HARTZELL PROPELLER INC.
ALERT SERVICE BULLETIN
TRANSMITTAL SHEET
HC-ASB-61-381
Propeller - Blade Bearing Races

August 16, 2018

Revision 1 is issued to change the following in the Alert Service Bulletin:

Figure 1

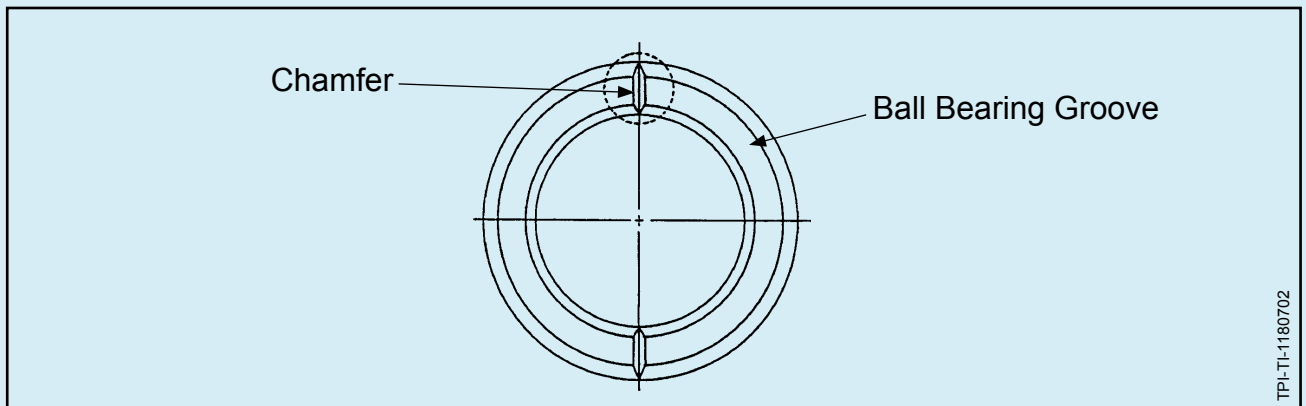
- (2) Bearings races without a "T" in the item number can be identified by a chamfer in the ball bearing groove located at the mating surface of the race halves. Refer to Figure 1.

A-1851-() Blade Retention Bearing
Figure 2

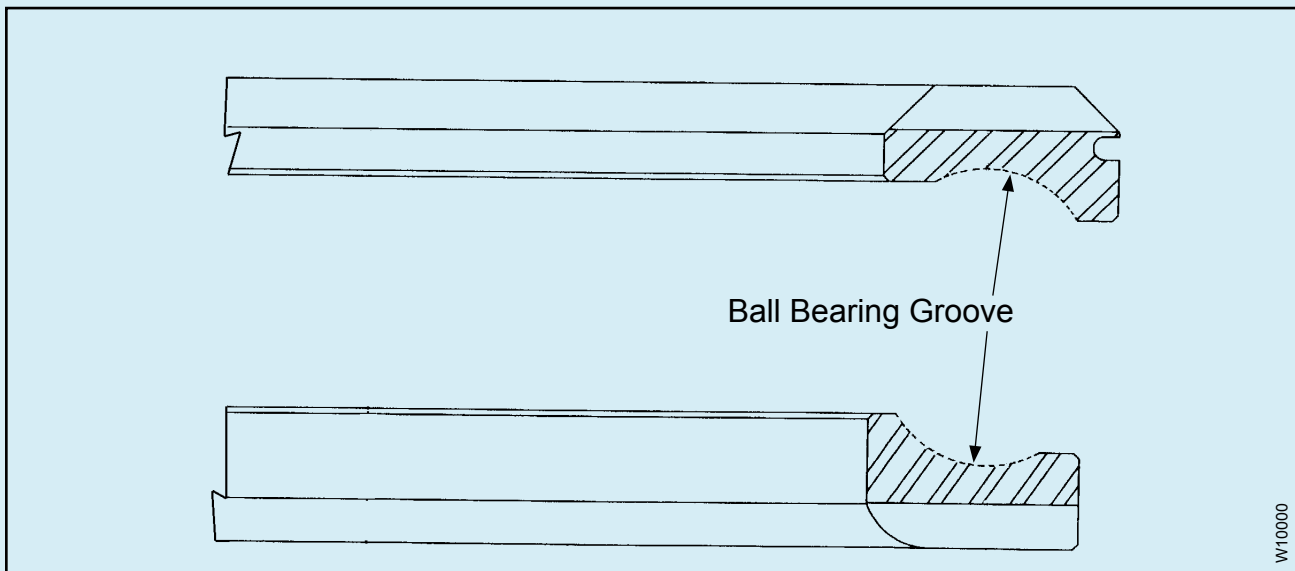
<u>A-1851-() BLADE RETENTION BEARING</u> Refer to Figure 2			
	Inspect	Serviceable Limits	Corrective Action
(1)	Visually examine the ball bearing groove for wear.	If the ball bearing groove shows wear, measure it. The maximum permitted depth of wear is 0.005 inch (0.12 mm).	If the wear is greater than the permitted serviceable limits, replace the blade retention bearing with a new A-1851 blade retention bearing.

(2)	Visually examine the ball bearing groove for cracks and chipping.	Cracks and/or chipping are not permitted in the ball bearing groove.	If there are cracks and/or chipping in the ball bearing groove, replace the blade retention bearing with a new A-1851 blade retention bearing.

(3)	Visually examine the blade retention bearing for corrosion and pitting.	Corrosion is not permitted. If corrosion is present, remove it in accordance with the corrective action repair limits. The maximum permitted depth of pitting, excluding the ball bearing groove, is 0.005 inch (0.12 mm).	Light corrosion can be removed with an abrasive pad CM47 or equivalent. If corrosion cannot be removed, replace the blade retention bearing. If pitting is deeper than the serviceable limits, replace the blade retention bearing with a new A-1851 blade retention bearing.
		Pitting is not permitted in the ball bearing groove.	If there is pitting in the ball bearing groove, replace the blade retention bearing with a new A-1851 blade retention bearing.
